**RE: Sonata Apartments, Phase II
Conceptual Grading Plans and Drainage Report
Engineer's Stamp Date: 10/25/22
Hydrology File: C10D001B**

RE Sonata Apartments, Phase II
Conceptual Grading and Drainage Plans and Drainage Report
Hydrology File: C10D001B

COA HYDROLOGY COMMENT RESPONSE

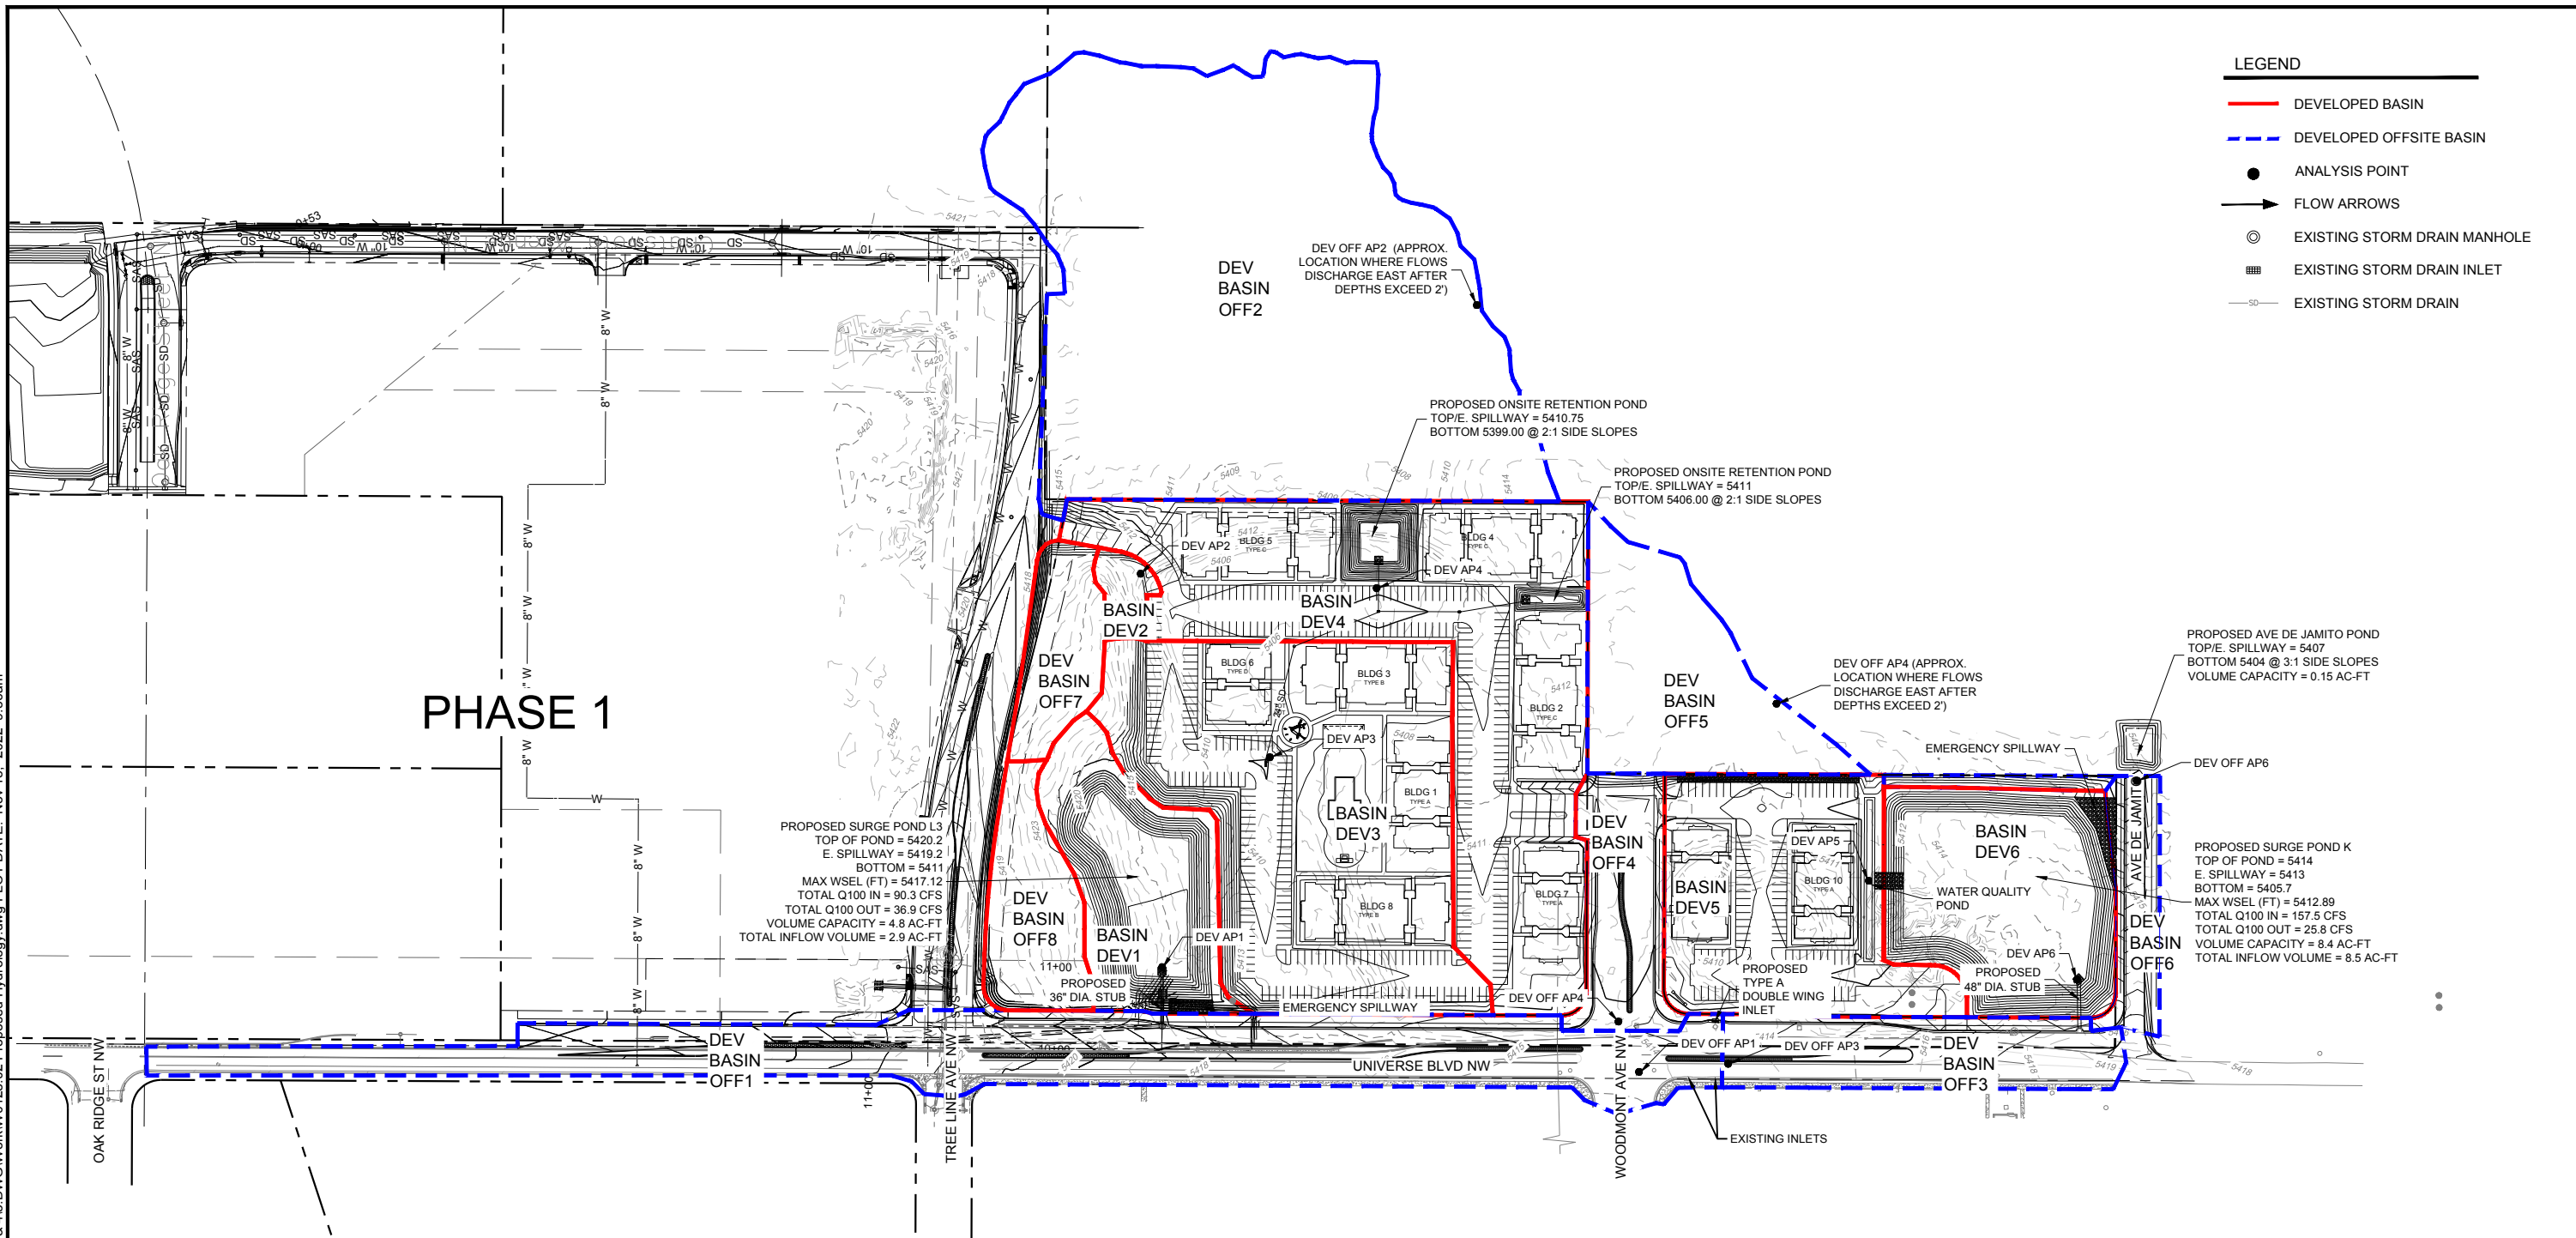
1. Exhibit 2 (Developed Basins). DEV Basin OFF1 needs to show to the high point in Universe Blvd (this will also include the future R.O.W. section). Also, please show the currently installed road work (CPN 761284). Some of the other basins on the north side needs to be revised as well. See the basin map below. [Revised](#)

- Exhibit 2 – How is the proposed on-site pond going to drain? If it isn’t draining through the on-site storm drain system, then it should be labeled as retention and have no outflow Q. If the outflow Q is assumed to be from infiltration state that in the report. [Revised on exhibit and report.](#)

SHEET NUMBER:		SHEET NUMBER:		SHEET NUMBER:		SHEET NUMBER:		SHEET NUMBER:	
C-201		C-201		C-201		C-201		C-201

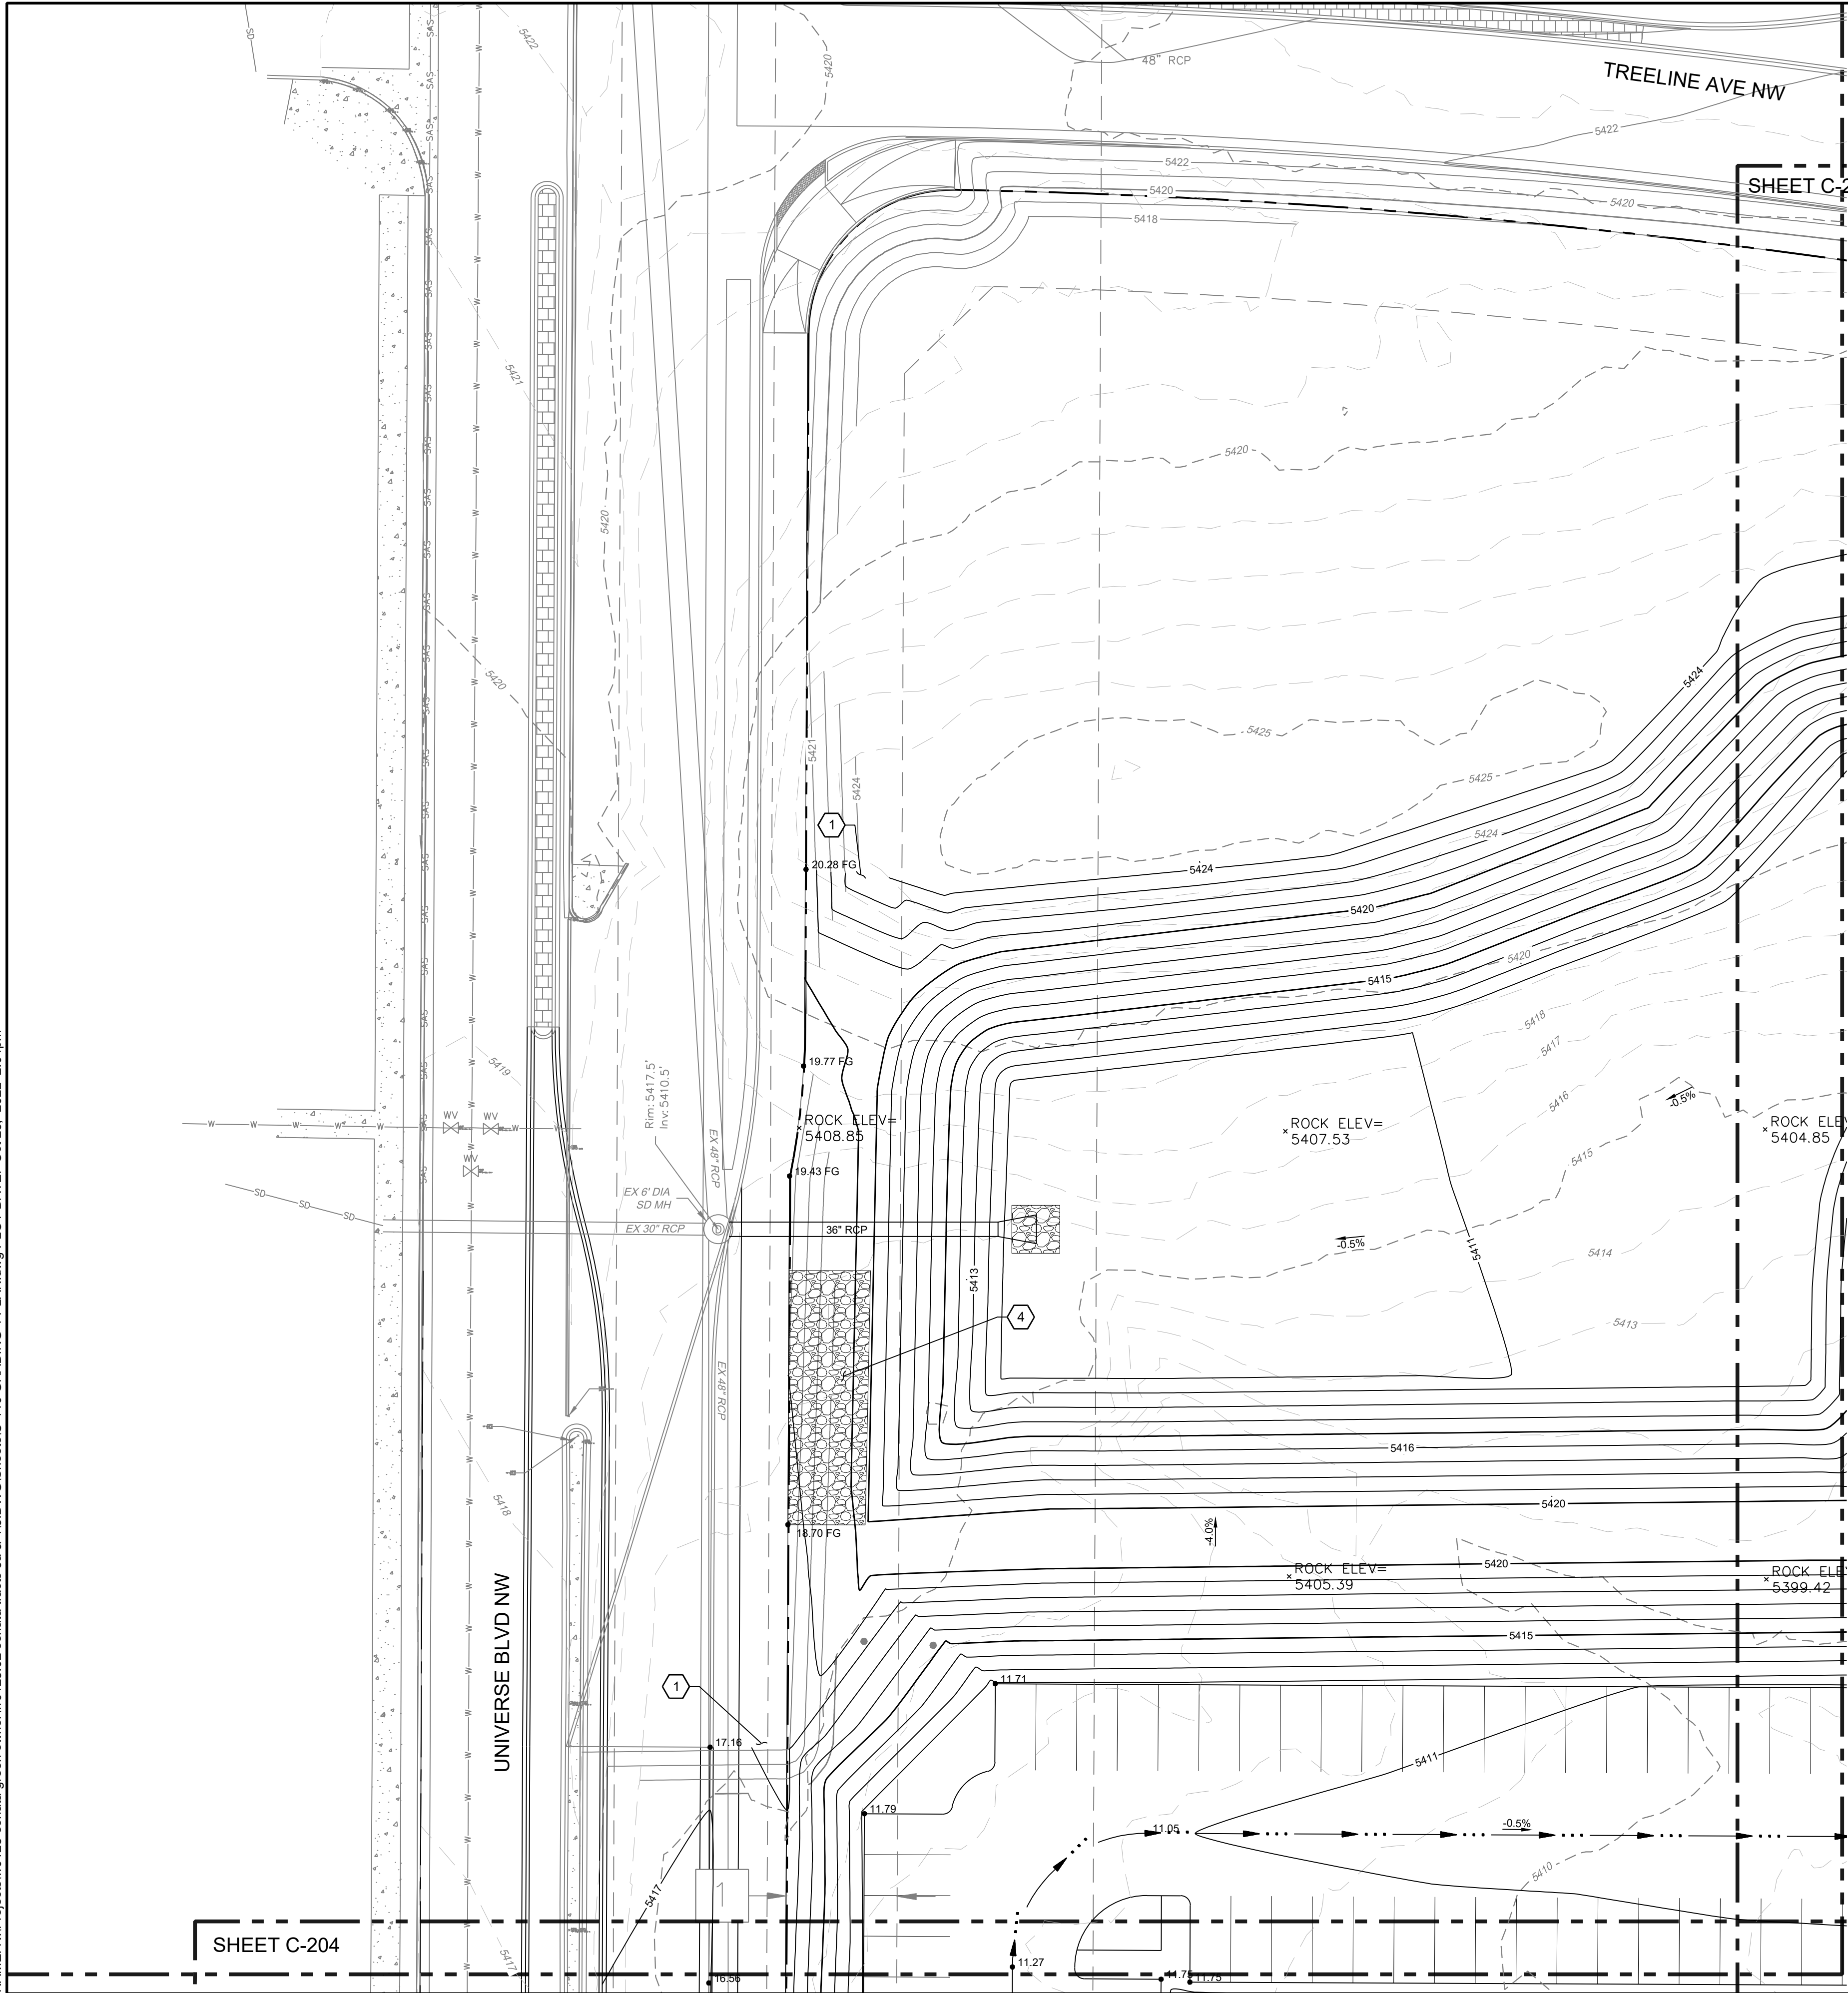
6. Sheet C-201 & C-202. Please show the grading that was done in Work Order (CPN 761284) within Treeline Ave R.O.W. [Revised.](#)

10. Sheet C-201. Please label the existing storm sewer and manhole as shown. Please make sure that any storm pipe over 30 -in is shown as a double line to the pipe's width. Also, the existing manhole is 6 - ft. Please reflect this in the drawing. [Revised.](#) There is three 48 -in pipes and a 30 -in pipe in the manhole. Please check to make sure that the manhole will be big enough for all of them. [Confirmed , all three pipes fit in the 6' diameter manhole .](#) Please shown an end section with some rip rap at the outfall into Pond L - 3. [Revised.](#)

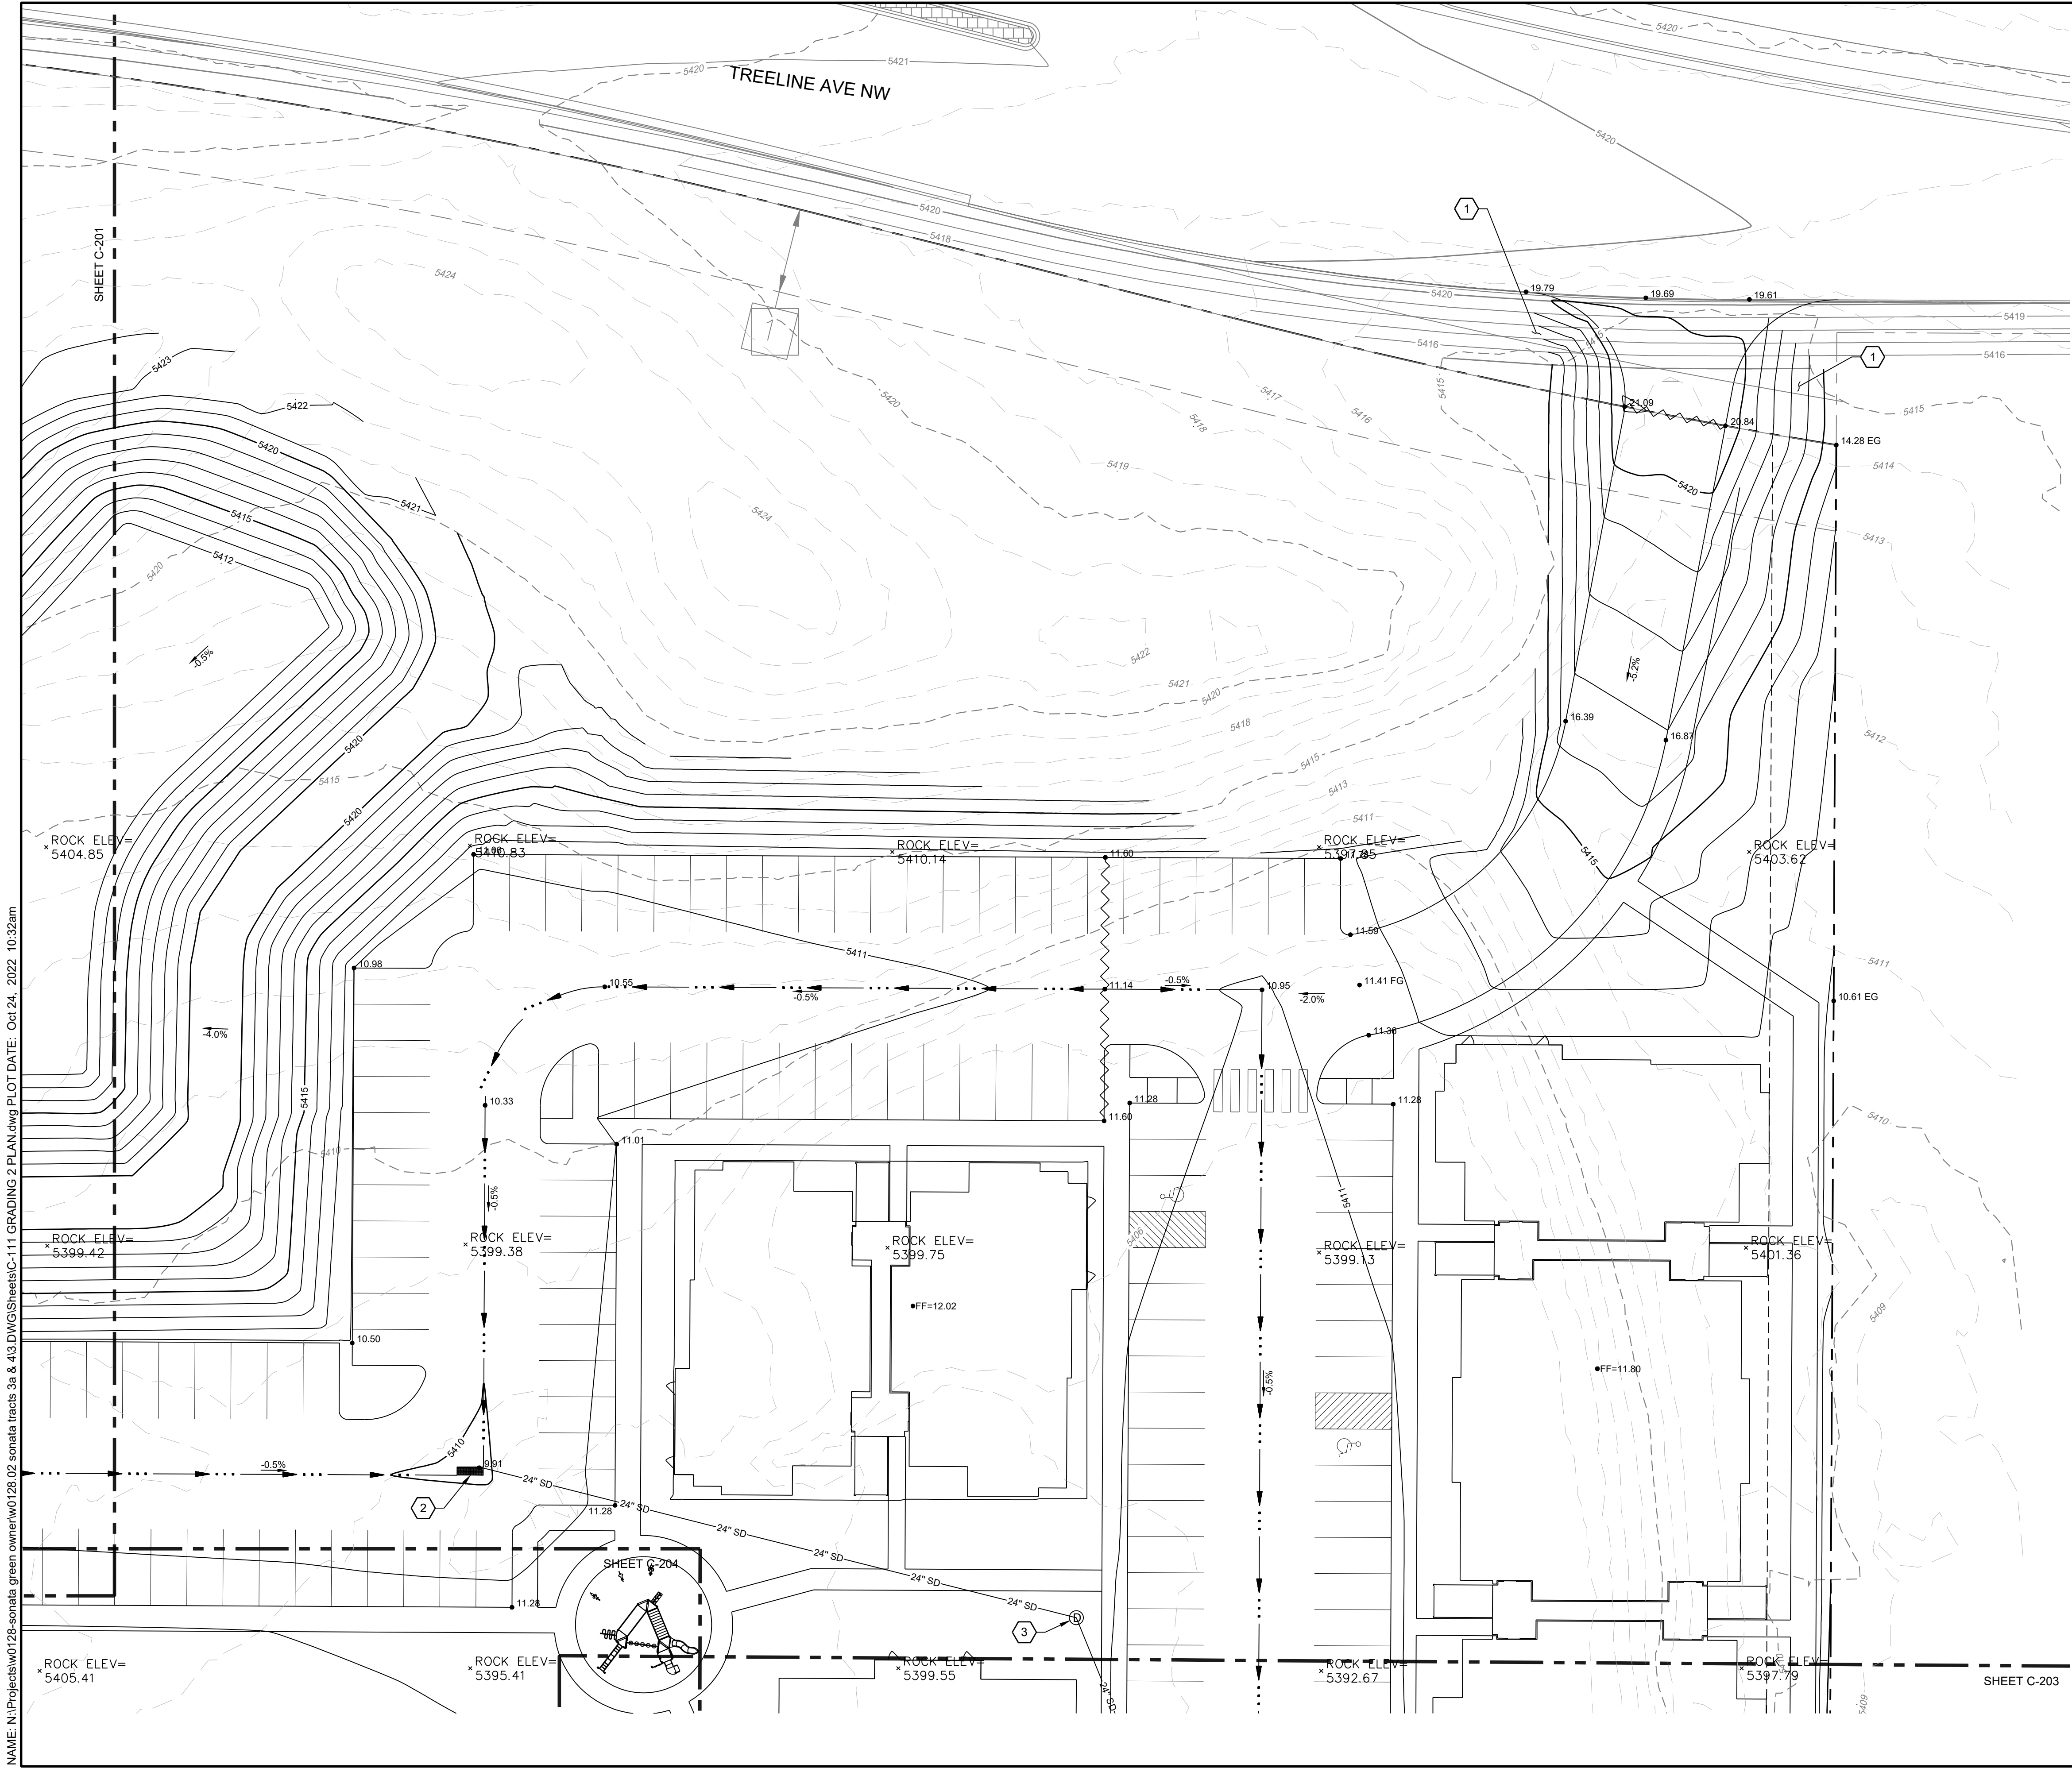
7. Sheet C-202. What is this hatch? If not needed, please remove. [Removed.](#)
